### **Connections**

#### Bekannte Designfehler

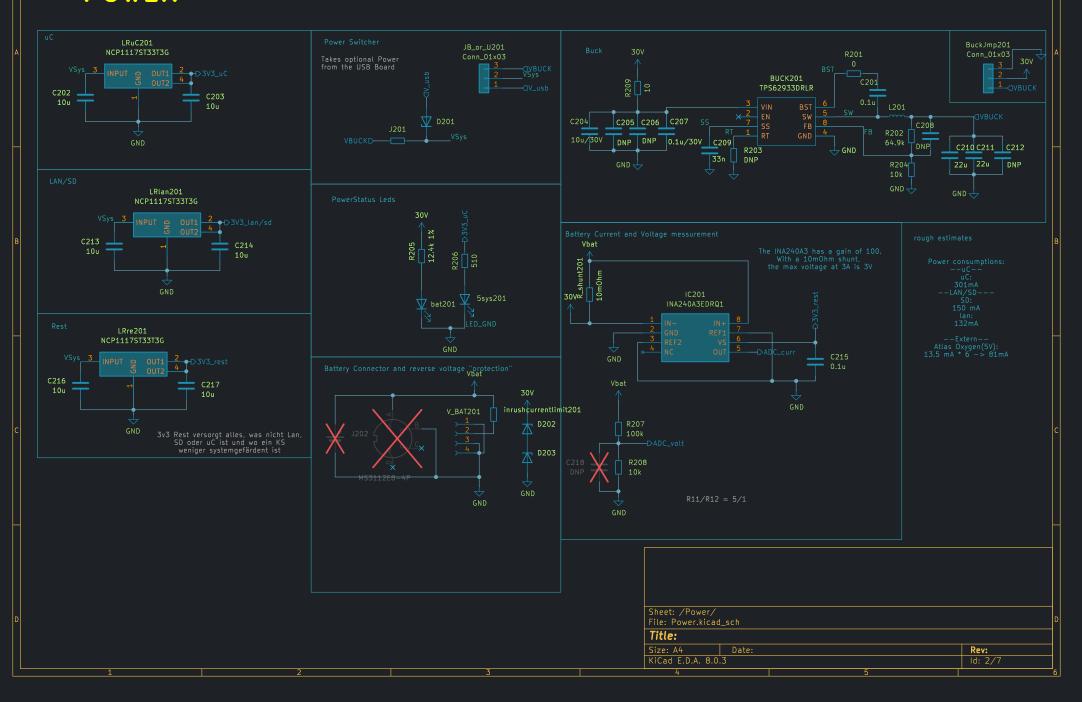
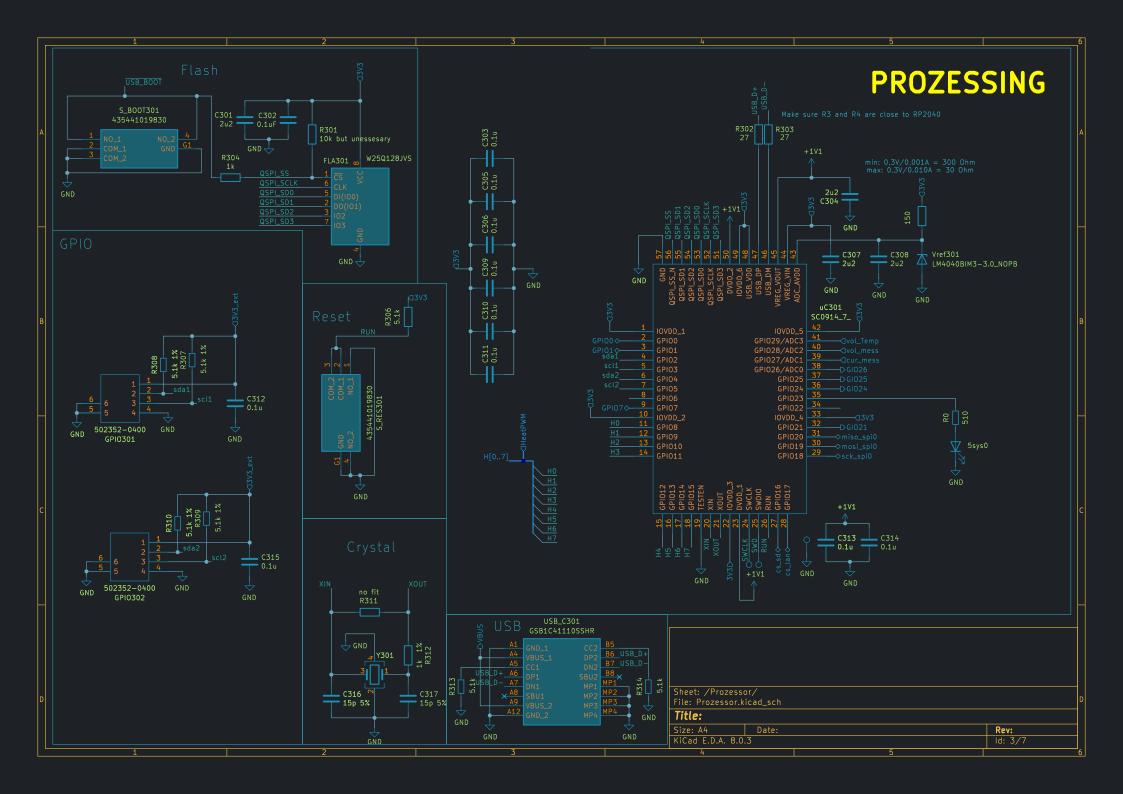
- keine seperate Analog/HF Groundplanes
- no ESD Protection
- Buck Heat Condensators won't decharge if heater off
- Inrush current limiting Resistor has to handle way to mutch power
- Oxygen UART O Pins swapped
- Oxygen 4 =! Probe 4, same goes for 5. Fix MUX
- Lowpass/PI filter on analog singals

- LDOs unnesessary before digital signals.
- better buck with filter
- USB-PD
- replace LDOs with low noise buck converter
- Rs hunt betwenn +VCC and 3V3 Opamp, Ground unused Opamp Inputs, extra opamp LDO
- EMF Capasitor Switcher
